Proposal Request

Project:
Intermountain Healthcare Lake Park North Level 1 Remodel
2545 College Drive
Murray, Utah 84123

Date: 07/21/2022
Proposal Request
PR # 01

Purpose for the Proposal Request: These modifications resulted from sewer district review comments, owner requests and contractor questions/ issues discovered during construction.

D2 FLOOR PLAN - LEVEL 1
A101 SCALE: 1/8" = 1'-0"

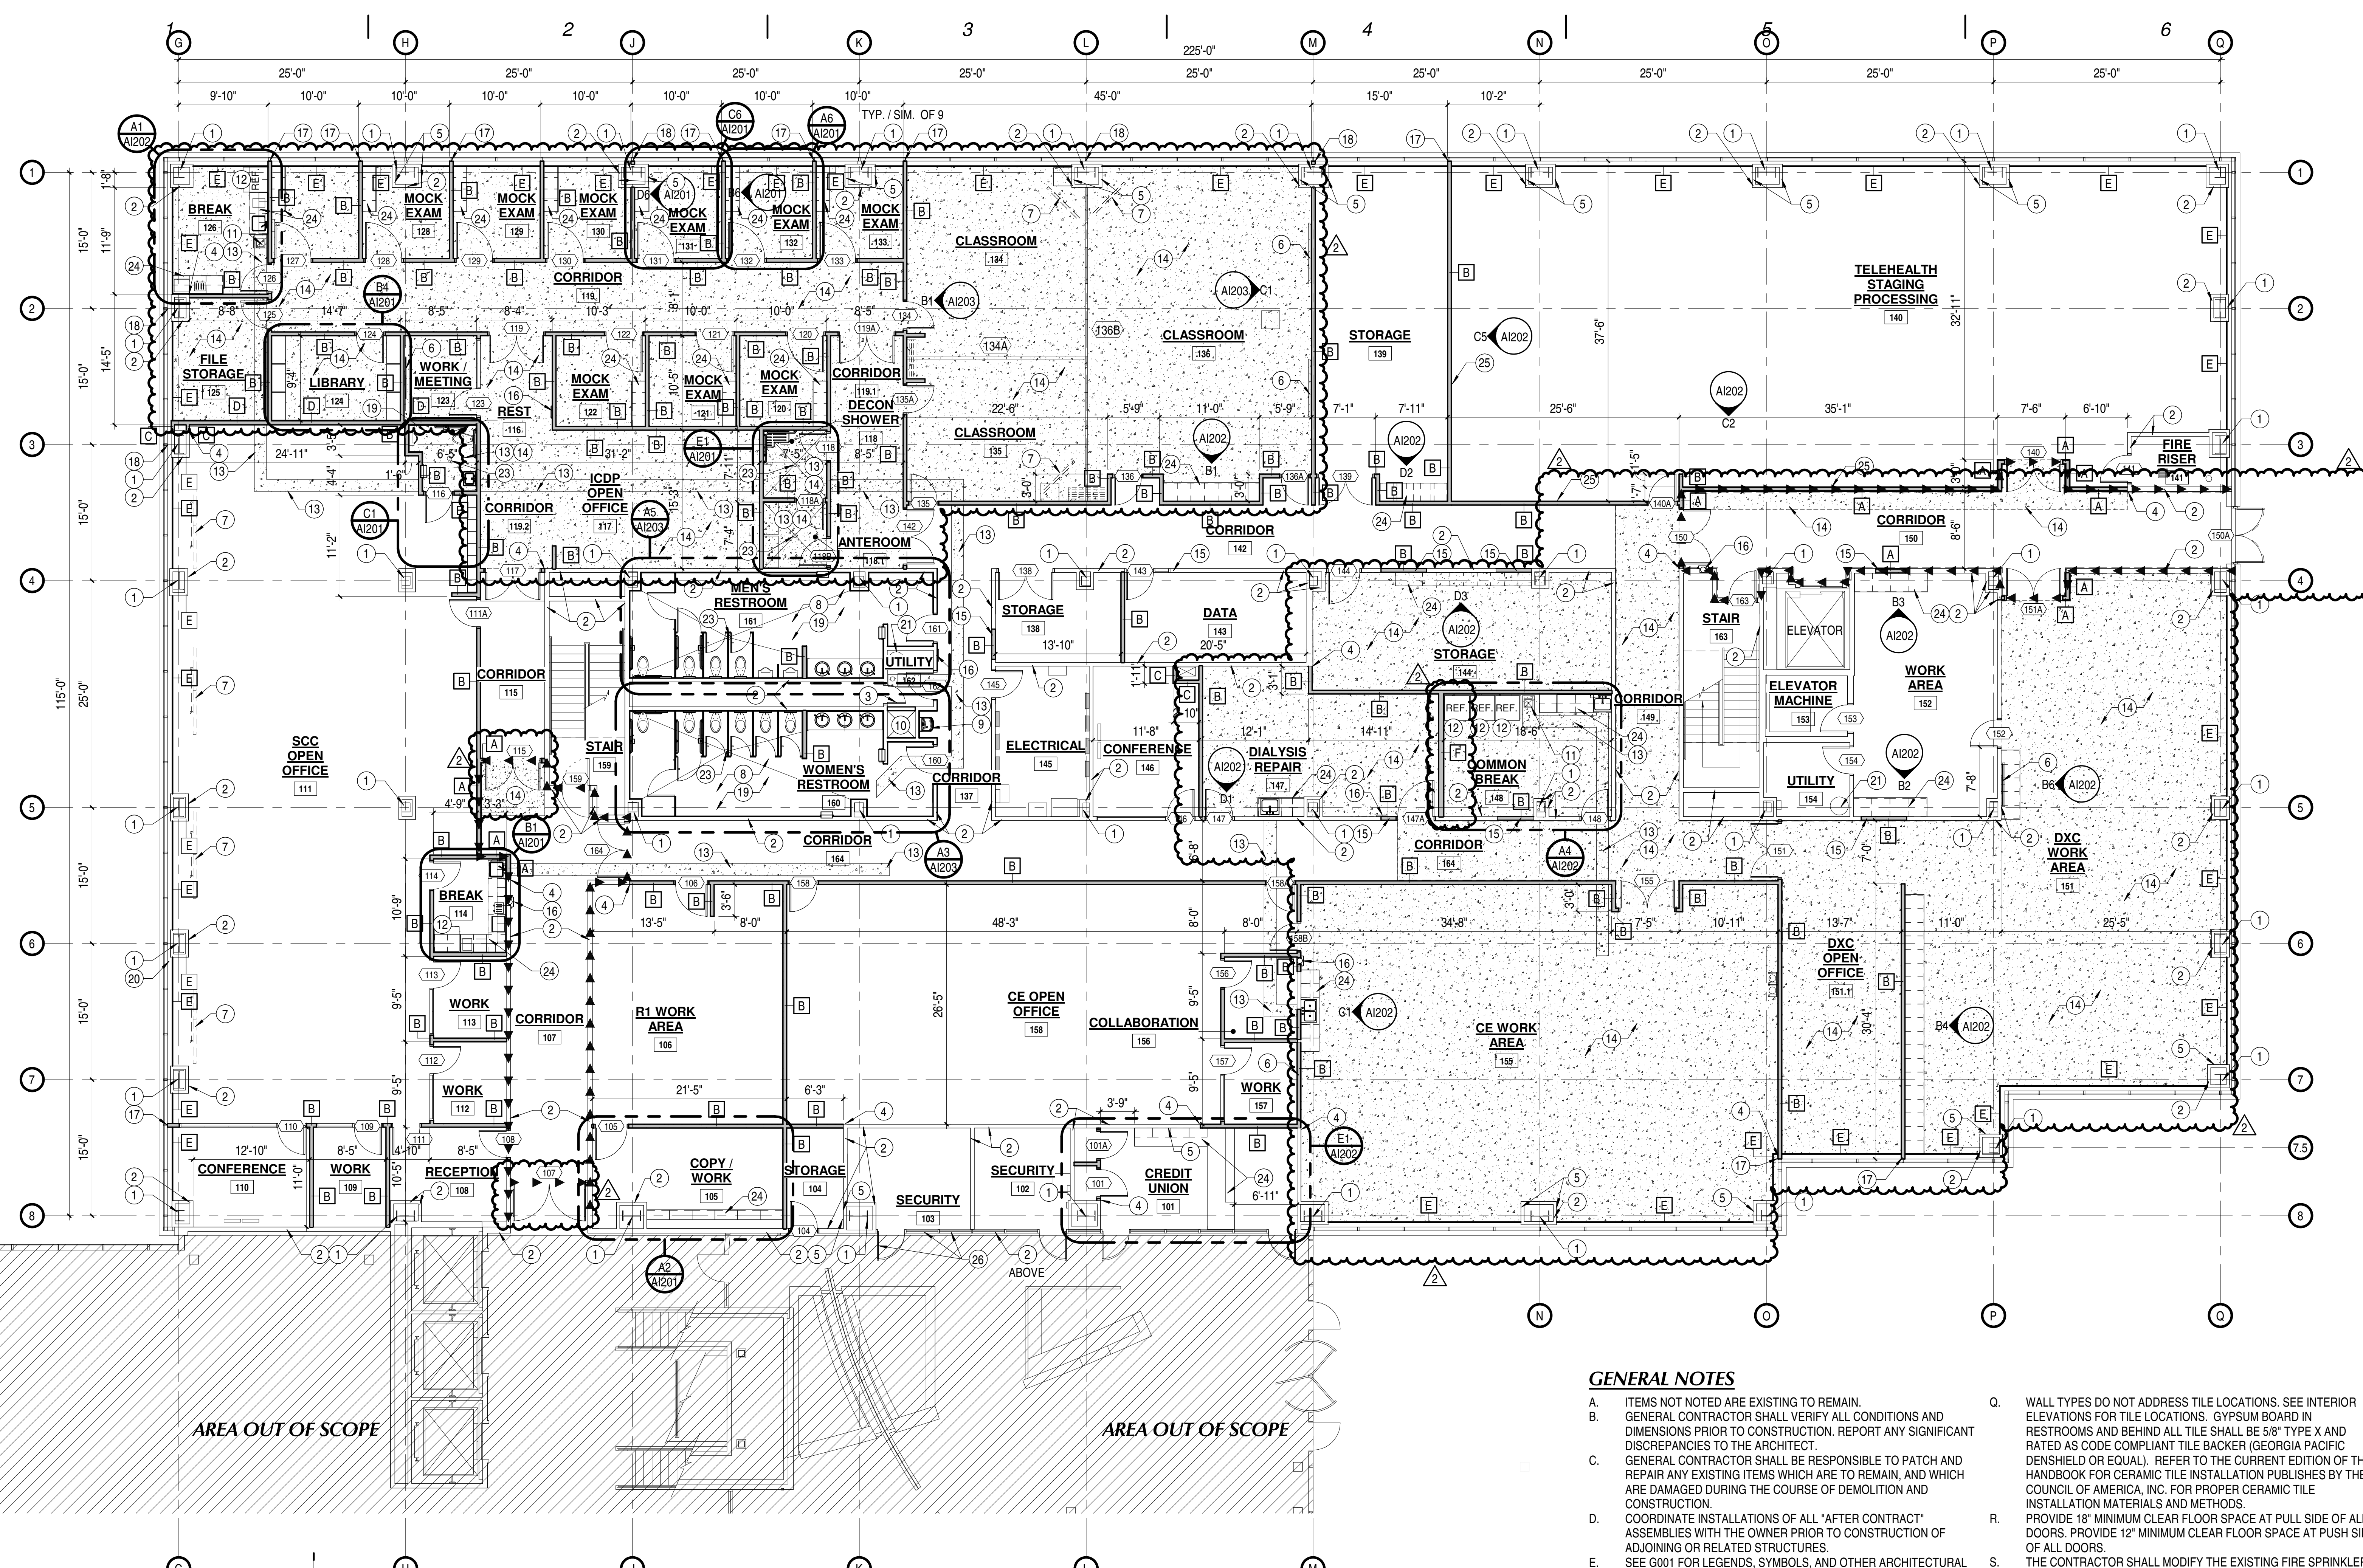
1. **RFI #01:** Per RFI #01, the question was asked whether new walls on raised access flooring had to extend to the lower concrete floor. The response was that new non-rated walls may be constructed on raised access flooring, but that fire rated walls are to sit directly on concrete floor. Due to this, some additional access flooring needs to be demolished and new concrete needs to be poured in its place in Corridor 107. See the original response to RFI #01, and the revised AD101 and A101 (General Note "DD").

2. **RFI #02:** Per RFI #02, the contractor asked whether fiberglass reinforcing can be used instead of the specified steel reinforcing. The response was that it could be substituted with 3 lbs. / cubic yard. See the original response to RFI #02, and the revised A101 (Sheet Note #14).

6. **Flooring Changes:** Whereas there were questions on how to maintain warranties on the sheet vinyl system over the raised access floor, various flooring changes have been made. Per Owner direction, some areas of raised access flooring are now being demolished, and some flooring has been changed to a thicker (4mm) version of the originally specified LVT flooring. Storage #139 was changed to LVT, Storage #138, Data Room #143, now won't have any flooring in order to maintain access to the raised access floor, and Utility Room #162 was changed to tile floor and base. Additionally, as part of the flooring submittal review it was determined that the sheet vinyl designations should be Biospec MD rather than FB. See the revised AD101, A101, and AI101.

7. **Exterior Concrete:** It was discovered that the exterior concrete that was noted to be removed and replaced has a snow melt system in it. Per Owner direction, it was decided to leave the existing concrete and to try rework the existing threshold to get as smooth of a transition as possible. See the revised AD101, and A101.

8. **Rated Corridor Ceilings:** It was discovered during construction that the fire rated ceilings that were believed to exist in the Corridor #107 and Corridor #142 are not fire rated. To meet code, it has been determined to demolish the existing ceilings and reconstruct them to maintain a 2 hour fire rating. Wall Type "A" has also been modified to show mineral wool insulation. See the revised AD151, A101, A151, and A501.

- WHEREAS MUCH OF THE EXISTING FLOOR SYSTEM IS ON RAISED ACCESS FLOORING, NEW NON-FIRE RATED WALLS MAY BE CONSTRUCTED ON TOP OF THE RAISED ACCESS FLOORING. FIRE RATED WALLS SHALL SIT DIRECTLY ON CONCRETE.

D2 REFLECTED CEILING PLAN - LEVEL 1
A151 | SCALE: 1/8" = 1'-0"

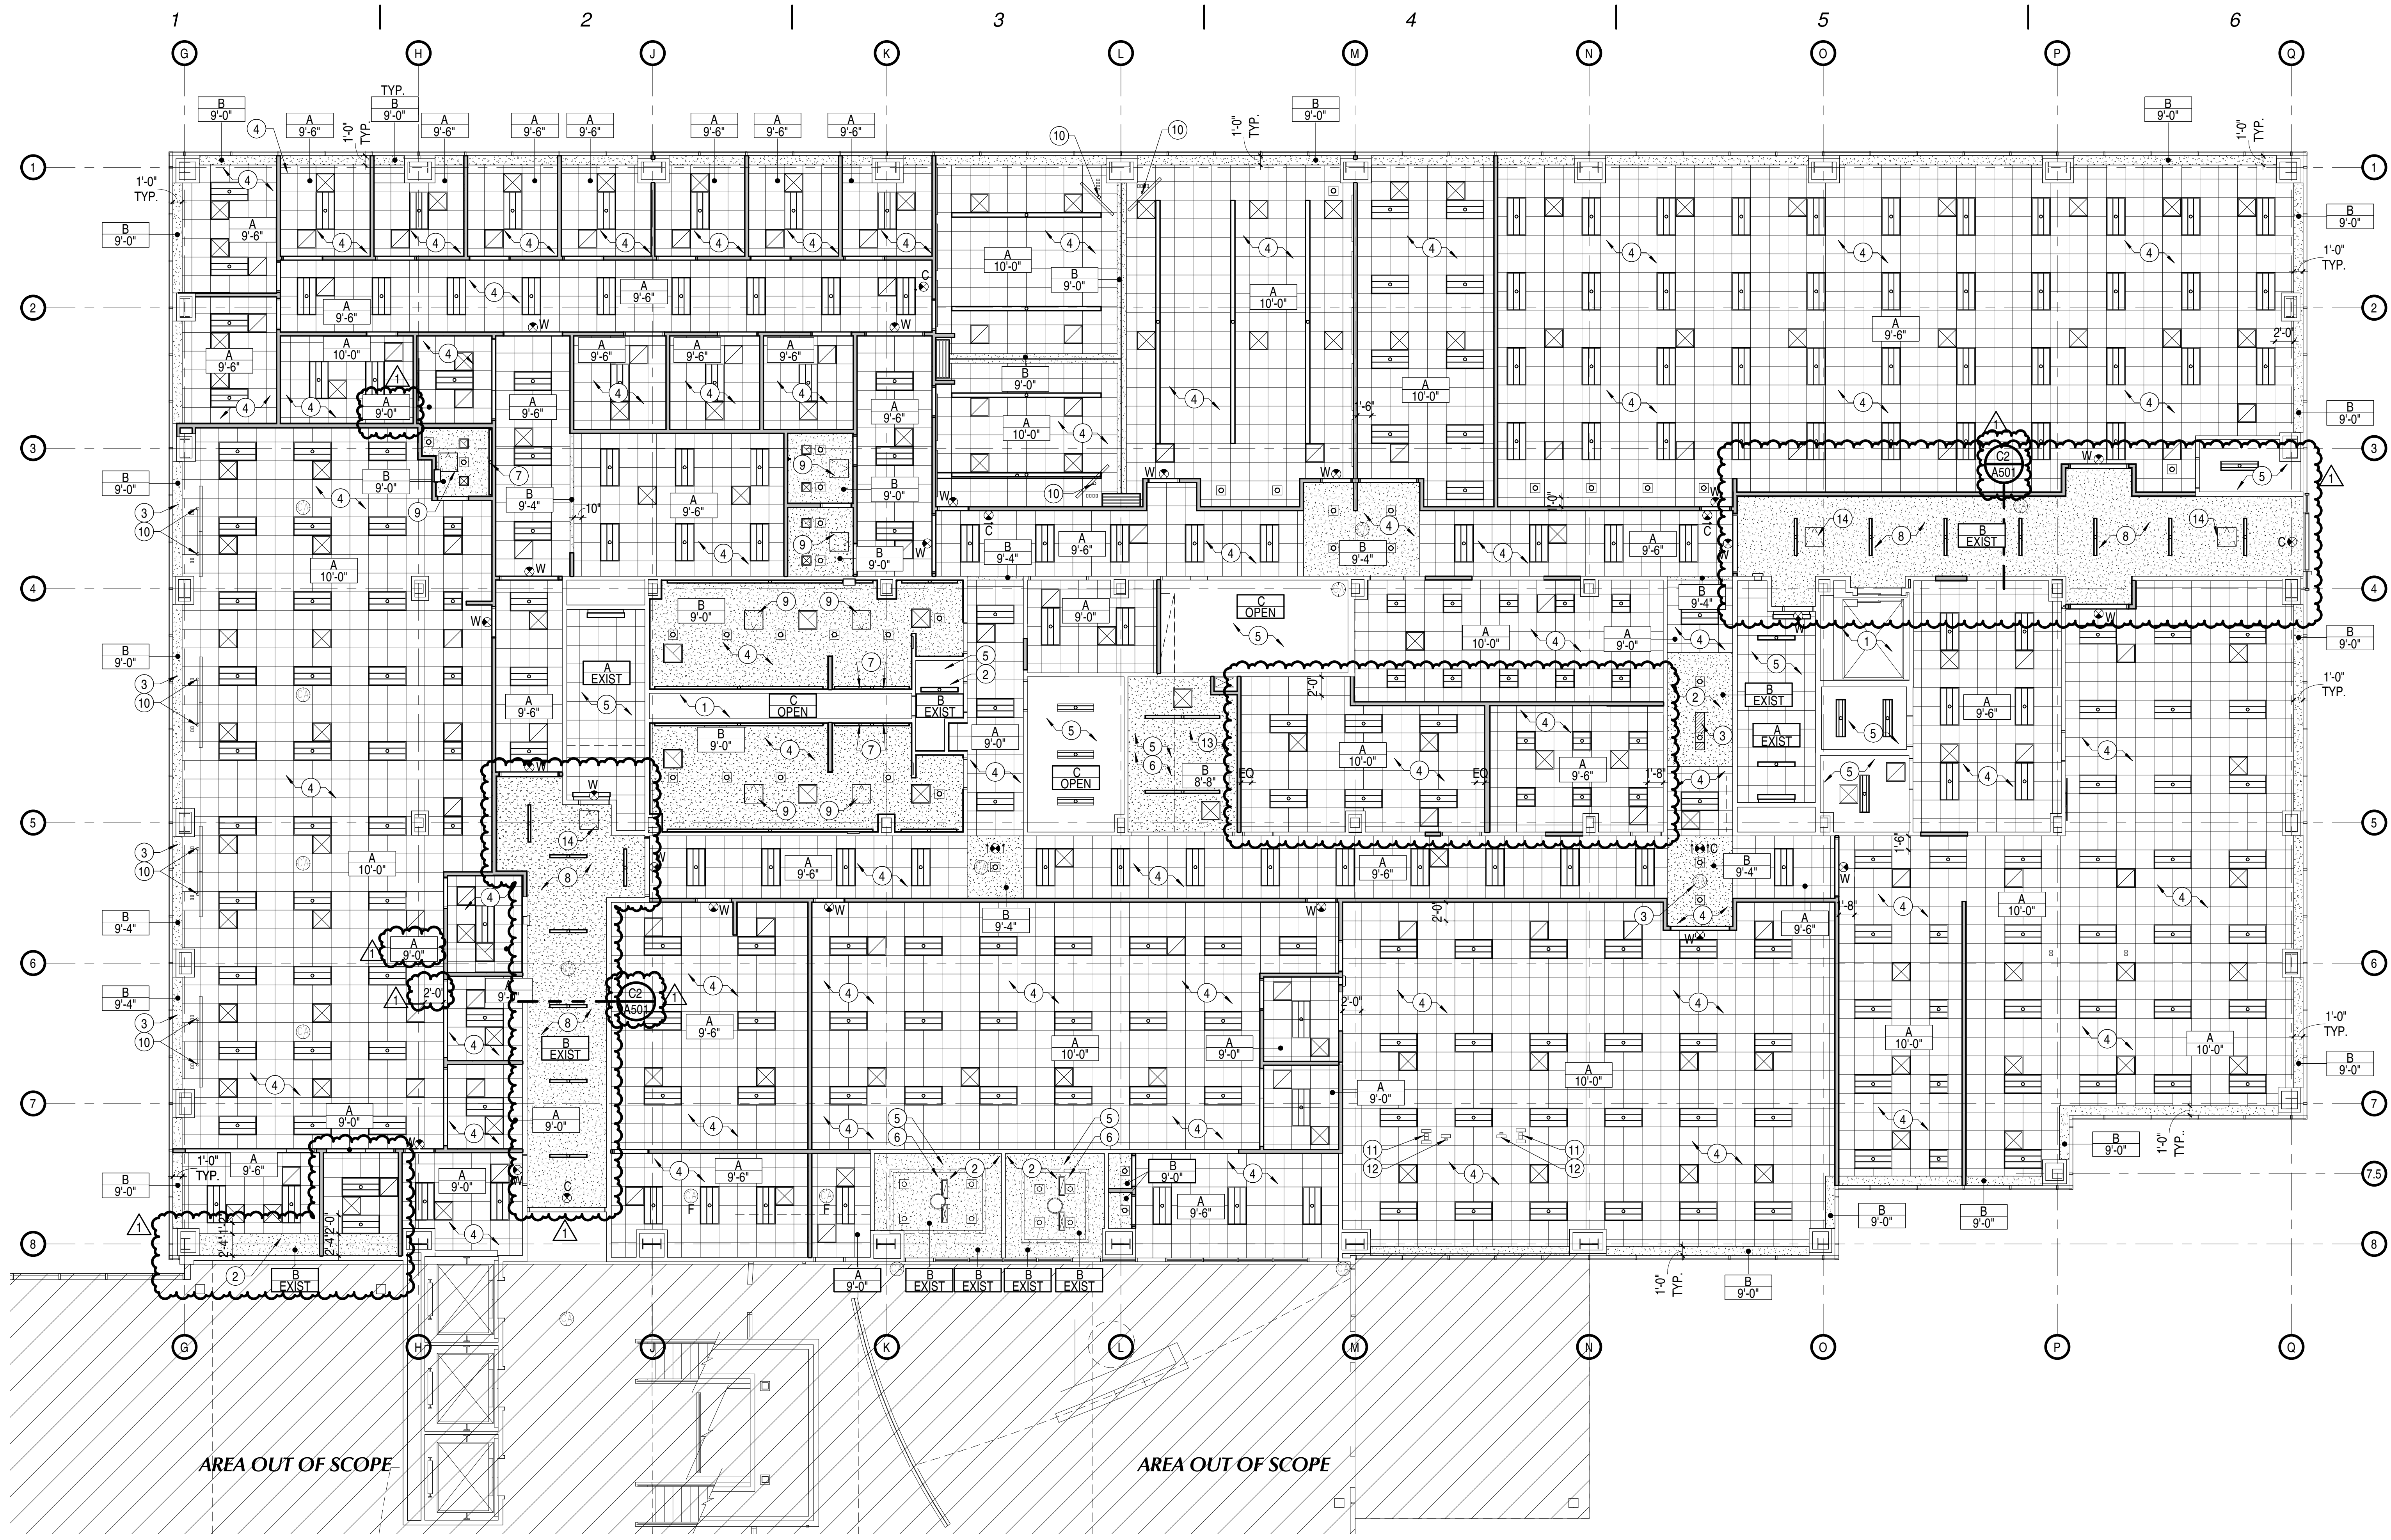
tile is to be demolished, the soffit is to be reconstructed, the wall is to be added in Break room #148, the drain line is to be repaired, and the ceiling does not need to be demolished in Security #103. See the original response to RFI #04, the revised AD101 (Sheet Note #10), A101, A151, AI101, AI202, and AP101.
